Access Compliance Report

Public Rights-of-Way

(Curb Ramps)

Intersection ID: 14831	Main Street: BARFIELD_DR	Cross Street: MANCHESTER_DR	Location: W
ADA ID: 3BBD13CC472C	Ramp Type: BlendTrans1	Initial Pass/Fail: Fail	Overall Compliance: No
Severity Score: 10			
Codes/Mitigation Info/Possible Solution		Field Measurements/Component Compliance

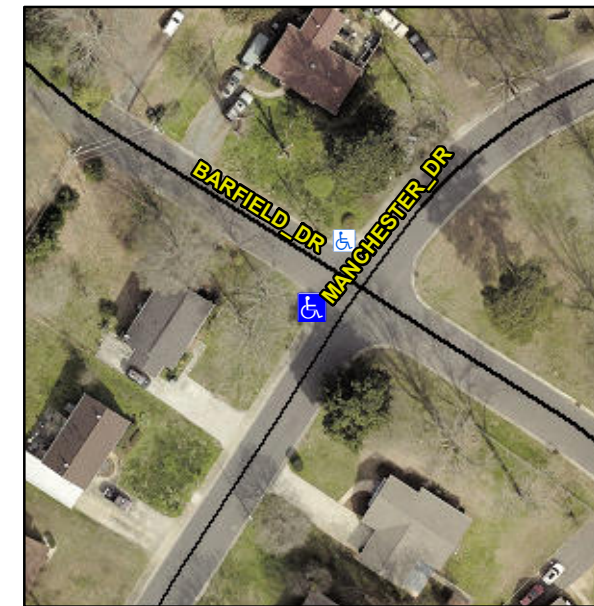
Not Found, R304.5.1, R304.5.3

Compliance	Description	Data	Compliance	Description	Data
N/A	Ramp Length (in)	49.0	Yes	BlendTrans Slope (%)	3.1
No	Ramp Width (in)	40.5	No	BlendTrans XSlope (%)	4.3
N/A	Flare Type LT	N/A	N/A	Flare Type RT	N/A
N/A	Flare Slope LT (%)	N/A	N/A	Flare Slope RT (%)	N/A
N/A	Flare Traversable LT?	N/A	N/A	Flare Traversable RT?	N/A
N/A	Landing Length (in)	N/A	N/A	DWS Provided?	N/A
N/A	Landing Width (in)	N/A	N/A	DWS Contrast?	N/A
N/A	Landing Slope (%)	N/A	N/A	DWS Length (in)	N/A
N/A	Landing X Slope (%)	N/A	N/A	DWS Full Width?	N/A
N/A	Landing Curb? (Y/N)	N/A	N/A	DWS Offset (in)	N/A
N/A	Shared Landing?	N/A			
N/A	Gutter Ponding?	N/A	N/A	Gutter Slope (%)	N/A
N/A	Gutter Lip Ht (in)	N/A	N/A	Gutter X Slope (%)	N/A
N/A	Painted X Walk1?	No	N/A	Painted X Walk2?	No
	X Walk 1 Direction	To SE		X Walk 2 Direction	To NE
	X Walk 1 Width (in)	N/A		X Walk 2 Width (in)	N/A
	X Walk 1 Slope (%)	2.5		X Walk 2 Slope (%)	7.1
	X Walk 1 X Slope (%)	5.2		X Walk 2 X Slope (%)	1.1

N/A	Ramp inside XWalk1?	N/A	N/A	Ramp inside XWalk2?	N/A
	Road Slope (%)	4.5		Clear Space?	N/A
	Road X Slope (%)	3.3	N/A	Clear Space to XWalk (in)	N/A
N/A	Any Obstructions?	N/A	N/A	Storm Grate/Utility Hazard?	N/A
	Obstruction Type			Storm Grate/Utility Type	
		N/A			N/A
			Yes	Surface Condition? (G/P)	Good
			No	Curb Slope (%)	9.5

Remove & Replace Curb Ramp With Two New Directional Ramps or Equivalent.
